SUPPLEMENTAL PACKET

Will Carlson Sketch Plan for a Preservation and Land Conservation Development Subdivision for 2018 acres of Land Located on 60th Street West of Trading Post Trail.

Feedback submitted by Annie Perkins, member Natural Resources and Groundwater Committee Member

Carlson PLCD feedback from Susan Winsor, NRGW committee

**Afton NRI
Figure 1.1**

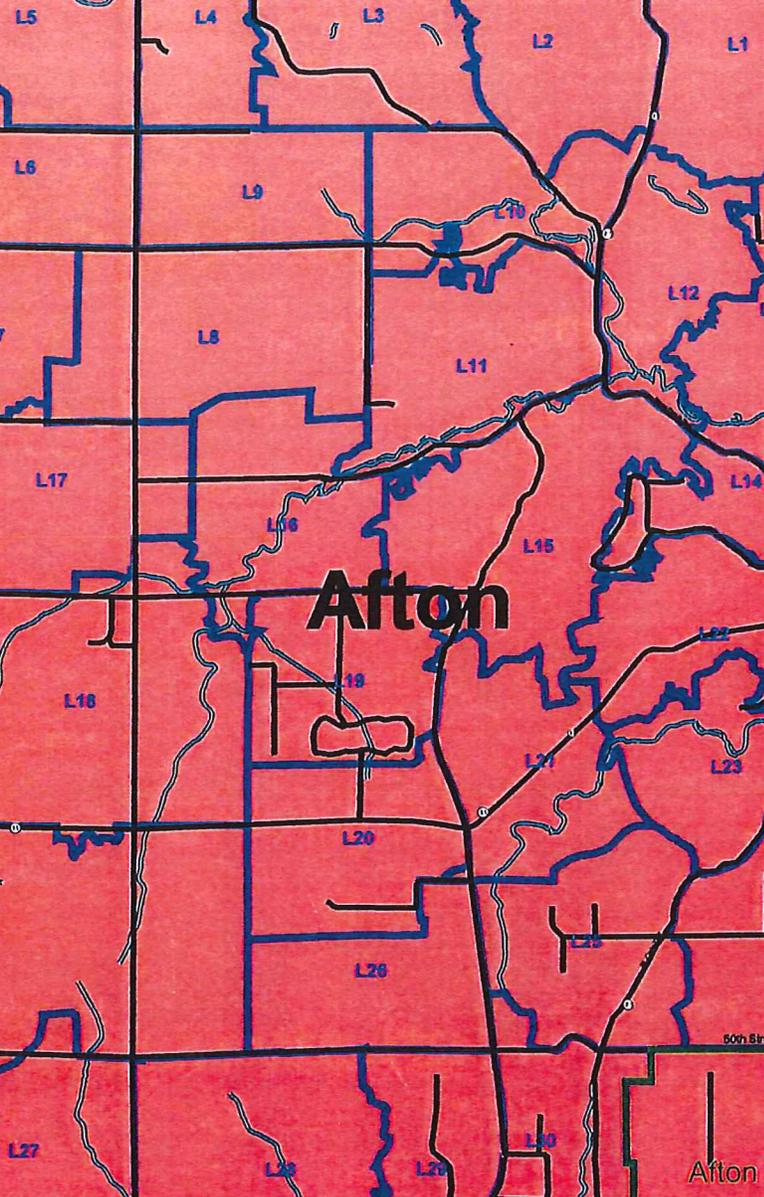
- Background/relevant context: per *Afton Natural Resources Inventory Final Report 2001* (pg. II-2) the PLCD, encompassing L28 and L29 of said report (see attached "Land Unit map"), has landscape rankings as follows:

- L28 - "Interesting landscape with group of bedrock knobs containing prairie remnants. Moderate quality northern hardwood forest and mesic oak forest. This landscape unit encompasses the headwaters of trout Brook."

- L29 - "Large area of moderate quality mesic oak forests. Good opportunity to engage local residents in stewardship activities."
 - **NOTE: criteria for a "high" ranking of Rare Features Potential is as follows: Documented endangered species and/or natural communities within site boundaries. Criteria for a "moderate" ranking of Rare Features Potential is as follows: Documented endangered species and/or natural communities adjacent to site -high potential for endangered species to be present on site due to good quality habitat (pg. IV-3).**

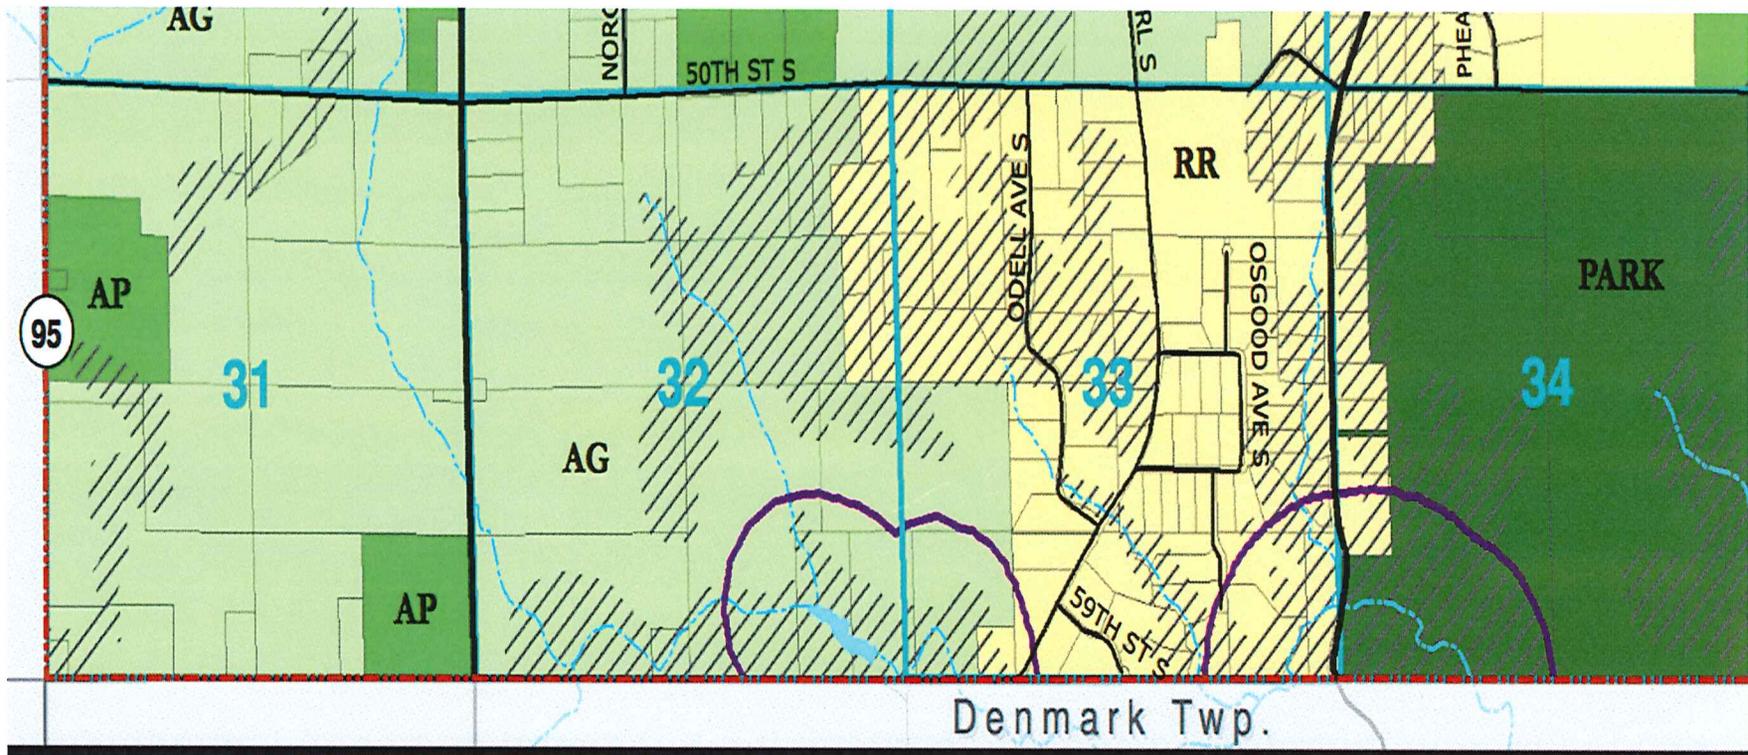
Superimpose the Conservancy Overlay District and the Shoreland District on this plat in order to fine tune these recommendations below, in order to reduce erosion and stream/river contamination:

*Remove Lots 1, 2, and 3 due to concerns about erosion into trout stream and river nutrient contamination. These appear to lie in the Conservancy Overlay District, and in part, in the Shoreland District.

*Convert Southwest corner of plat, South of stream, to Afton parkland as parkland dedication fee. Append any land that exceeds the 7.5% of land value stipulation to the Open Space Conservation Easement.

*Lots 4 & 5: Add parts with slopes above 13% to the 10-acre adjacent Open Space immediately to the West, and the remainder comprises one lot instead of two, if eligible per Afton zoning laws. These appear to lie in the Conservancy Overlay District, and in part, in the Shoreland District.

*Lots 9 and 10: Append to adjacent Open Space Conservation Easement for reasons of slopes above 13% grade.

*Lots 14, 15 and 16: Add those lot portions with slopes exceeding 13% to the adjacent Open Space to the North. Remaining portion comprises one lot, or whatever the remaining less steep landscape represents.
